POV Parking Lot Improvements Design Build, Camp Denali Building 49000, JBER

DATE AMENDMENT 2 ISSUED: August 13, 2018

This amendment is for informational purposes only and need not be returned to the State. This is a response to questions that arose from the Pre-Bid Conference August 8, 2018 and Site Visit August 10, 2018.

Figure A

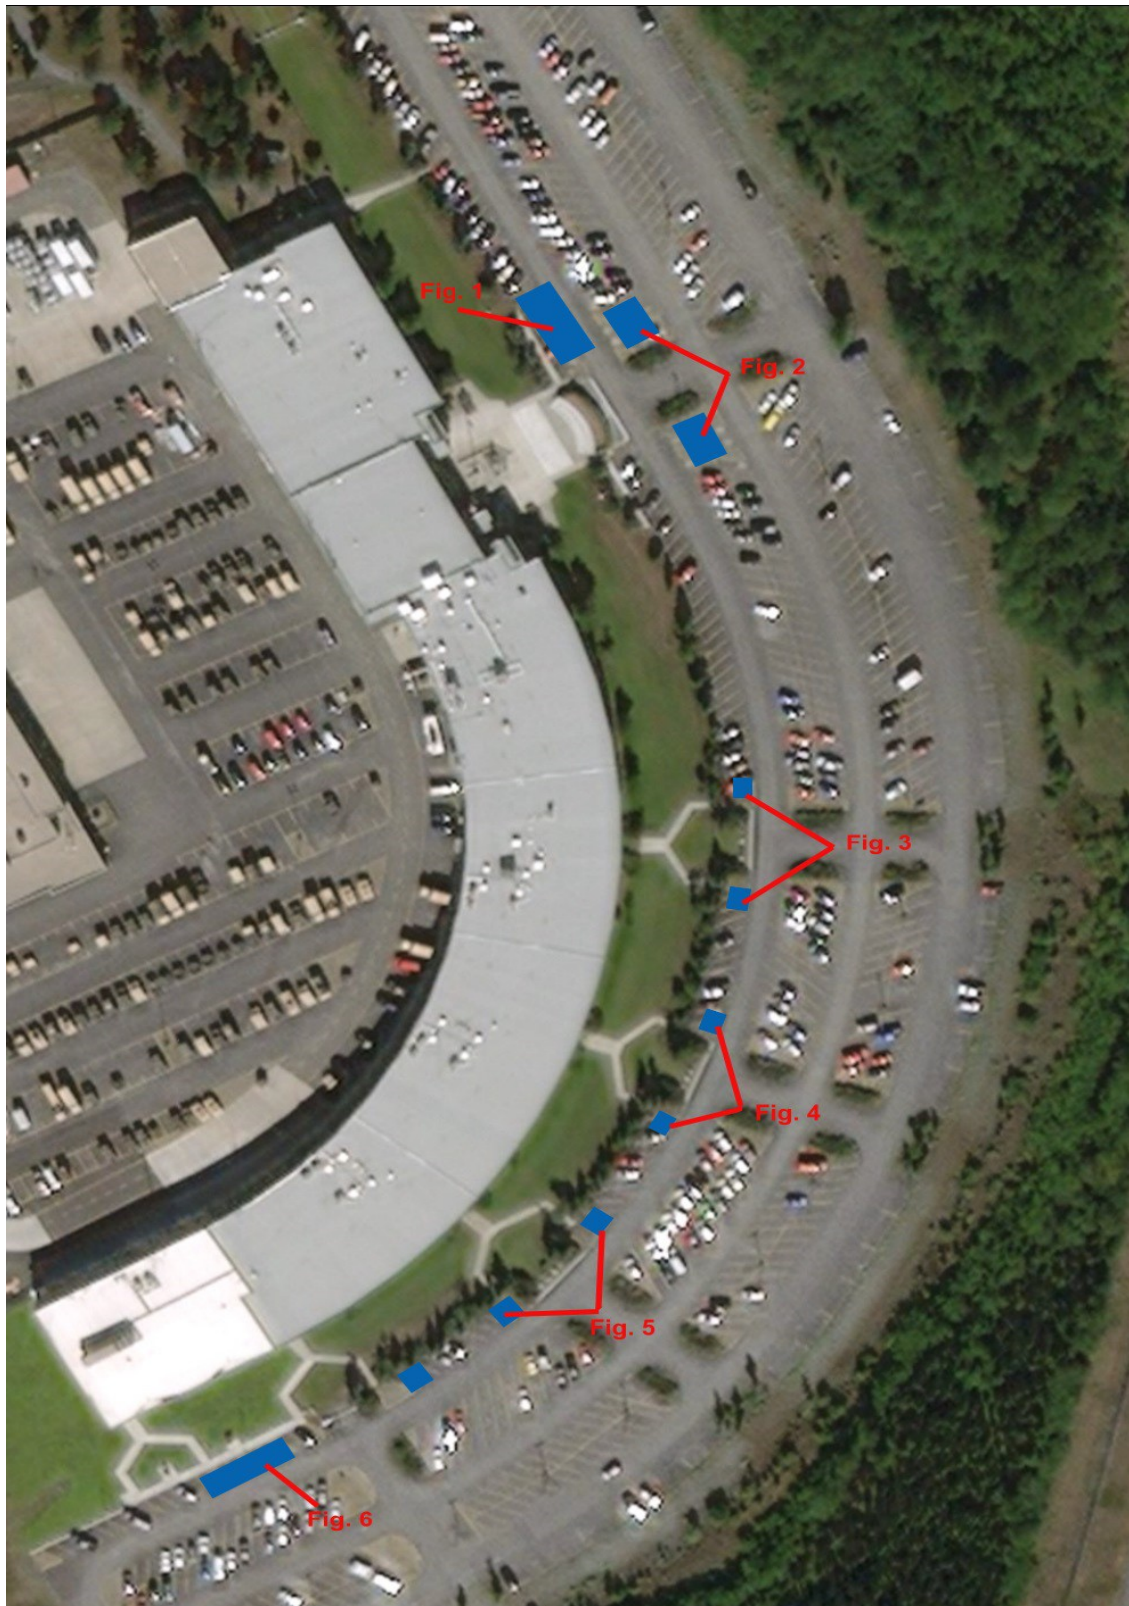
15. Is there an ADA parking guideline available?

Yes. Please see the following document for reference.

1. There are 626 marked parking spaces at the Anchorage Armory. In accordance with the chart below (Figure B) the Armory has a requirement to have a minimum of 10 Standard Accessible Spaces and also a minimum of 3 Van Accessible Handicap Spaces.
2. There are 29 Handicapped Accessible Parking Spaces. (Marked with the Blue Universal Handicap sign painted on the asphalt/ground.)
3. The location of these handicap spaces are indicated in Figure A below.
